**SOUTHEAST FEDERAL CENTER OVERLAY REVIEW  
PARCEL D, SQUARE 826**

M Street and 4th Street, SE  
Washington, D.C.

**Delegated Action of the Executive Director**

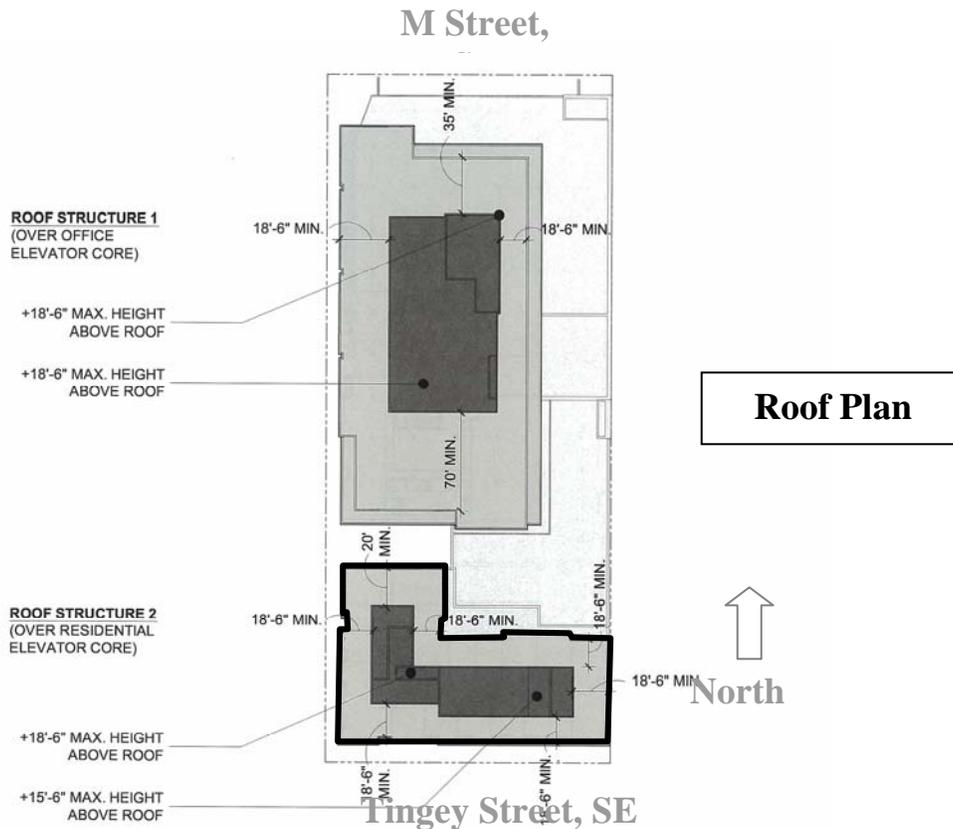
At the July 12, 2007 Commission meeting, NCPC approved the 35% design submission for Parcel D. The submission included the Tingey Street perspective and the roof plan shown above.

If constructed according to the plans shown herein, the proposal would not be inconsistent with the Comprehensive Plan for the National Capital nor have an adverse affect on any identified federal interests. The proposal would comply with the Height of Buildings Act of 1910 because rooftop mechanical penthouses are set back from all of the exterior walls of the buildings a distance equal to their heights above the adjacent roofs.

Alternative designs requiring setback relief for roof structures, with rooftop structures that are not set back from all exterior walls, would violate the Height of Buildings Act, which allows mechanical penthouses above the limit of height only if they are set back from all exterior walls a distance equal to their heights above the adjacent roofs.
